## RT809H Programmer Technical Upgrading Notification

NO:20170001

### Component location:

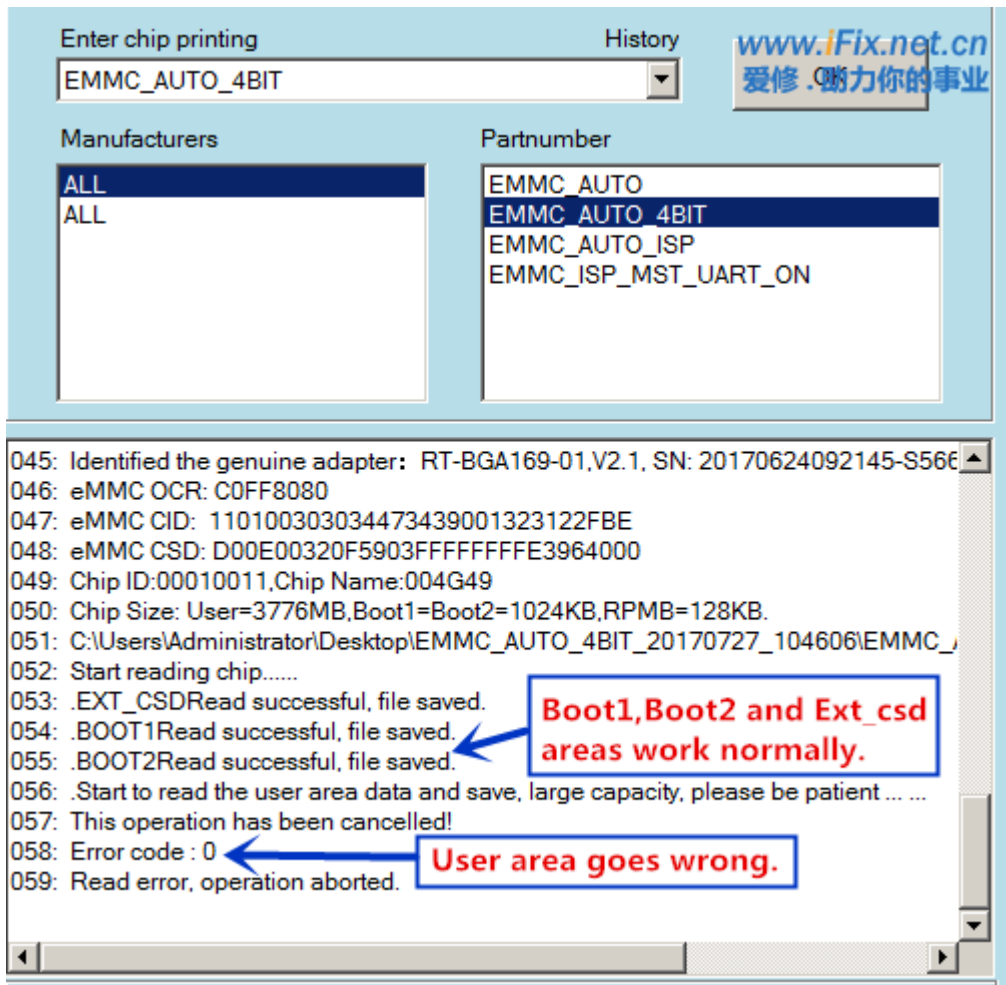
- 1 : R26 Resistor Original parameter is 12K or 10K ; Modified parameter is 4.7K
- 2 : C18 Capacitor Original parameter is 106 ; Modified parameter is 476/10V
- 3 : C22 Capacitor Original parameter is 104 ; Modified parameter is 476/10V

Notes : If can' t find the capacitor with patch for the C18/C22,then use the electrolytic capacitor parallel (pay attention to the polarity) connected with 47uF-100uF/16v.
